SUPPLEMENTAL INSTRUCTION

PROJ.: **Dovercourt Phase 2**
PROJ. No.: **1712**
DATE: **Nov 20, 2017**
S.I. No. **S.I. - 002**

1.1 TITLE
Revision to Fire Protection

To:	Barry J. Hobin & Associates Architects Inc	Project ID.:	Dovercourt Phase 2 411 Dovercourt Ave
Att:	Doug Van den Ham Sandy Davis	Project No.:	2017-09
Subject:	Sprinkler pipe Connection	CCN No.:	MCCN-01
		Date:	November 17, 2017

1. Drawing M-4 Fire Protection Rev 3:

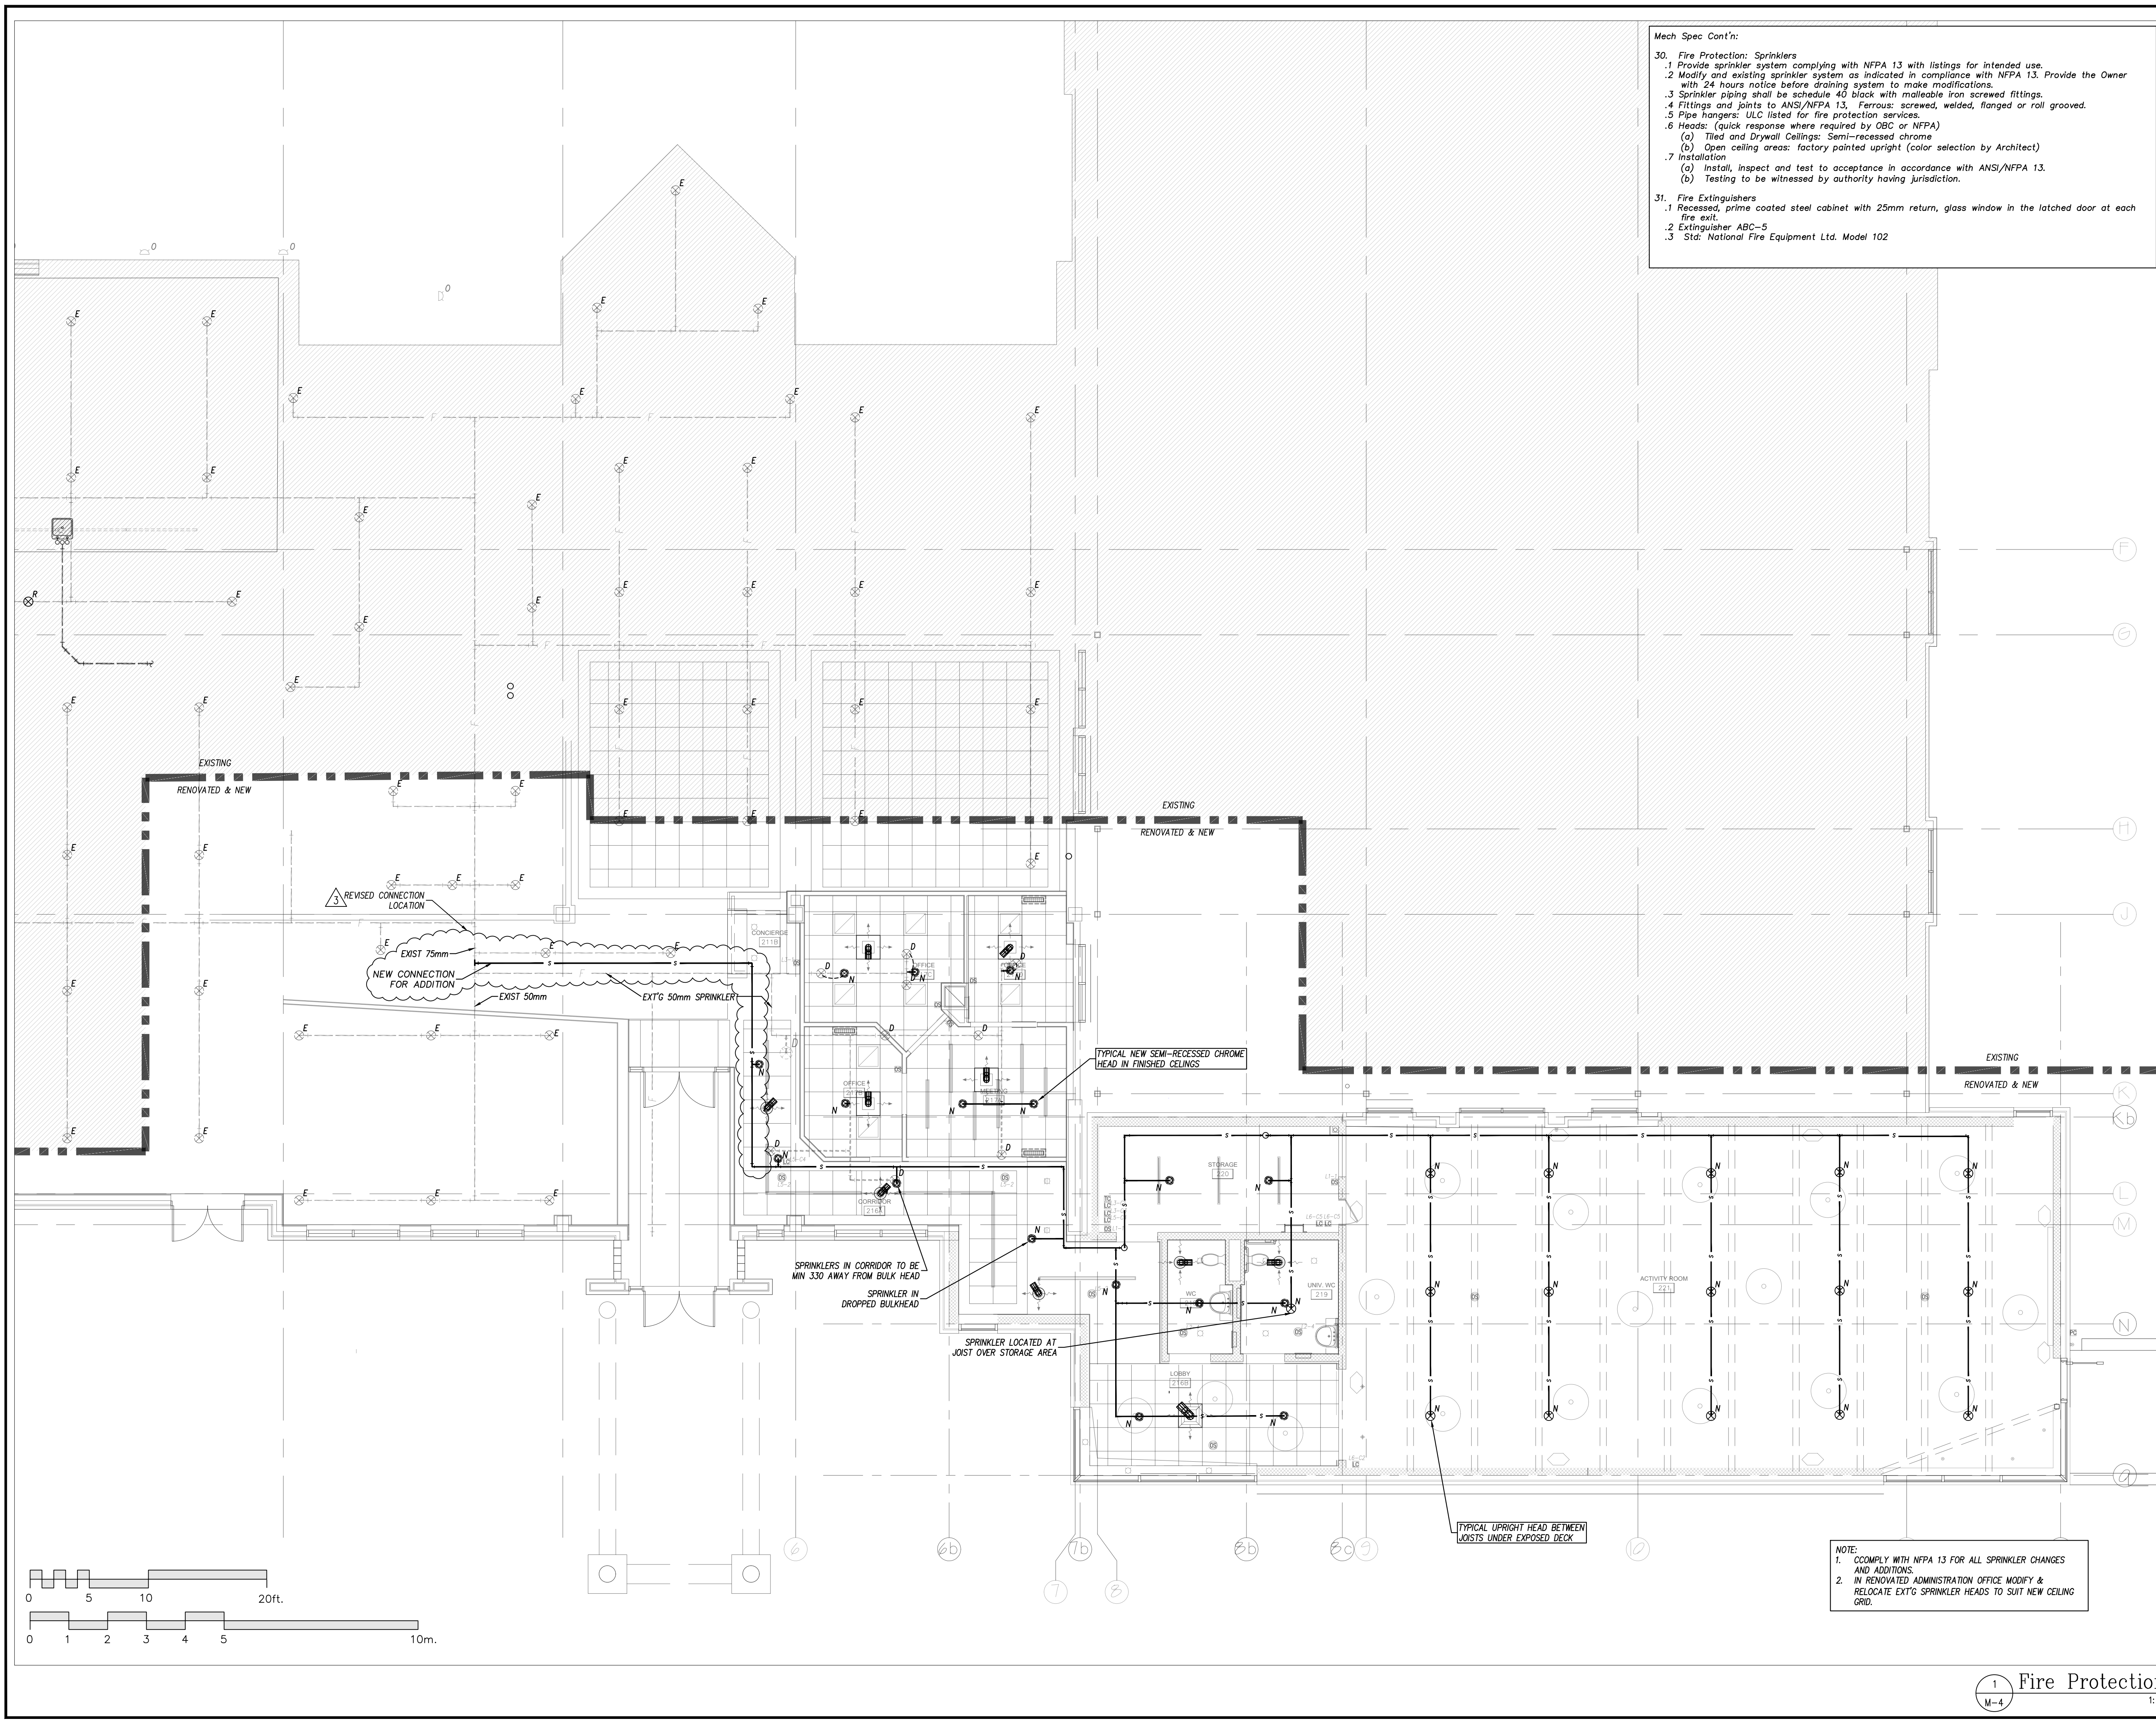
- a. Change connection location for Activity room piping from 50mm in office area to 75mm located in corridor by washrooms
- b. Increase pipe size thru activity room to 75mm
